## Detailed Site Plan Alternative Compliance Adelphi Friends Meeting, Inc.

**DSP-20039  
AC-21012**

REQUEST	STAFF RECOMMENDATION
Construction of a 4,660-square-foot addition to an existing church, including office space, religious education classrooms, and fellowship space.	APPROVAL with conditions

**Figure 1: Site Plan**

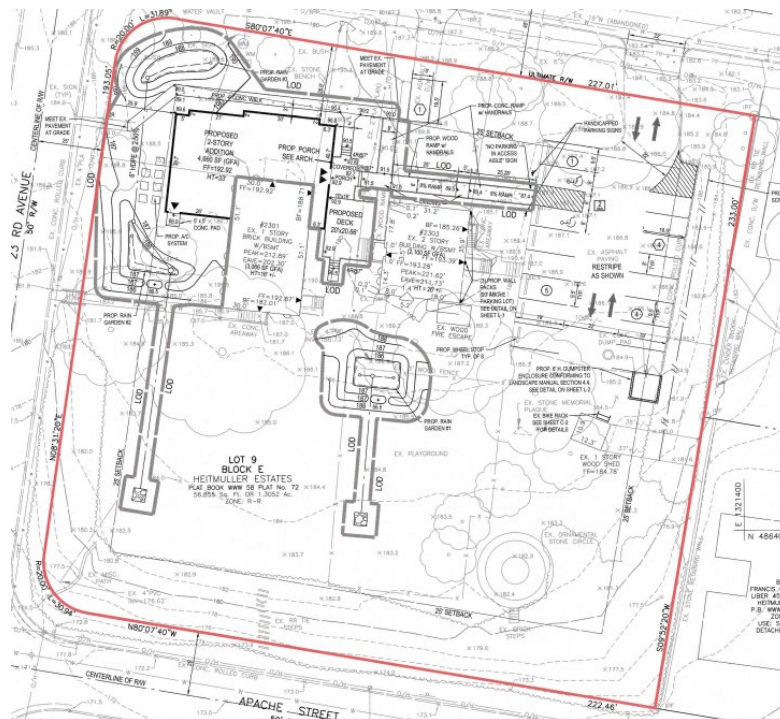
There is one parking space located in the front yard, however the remaining parking spaces are located in the side yard, in conformance with this requirement. Eight of the required 25 parking spaces are located off-site.

The maximum allowable lot coverage for the R-R Zone is 60 percent. The submitted DSP indicates the proposed lot coverage is 18.3 percent in conformance with this requirement.
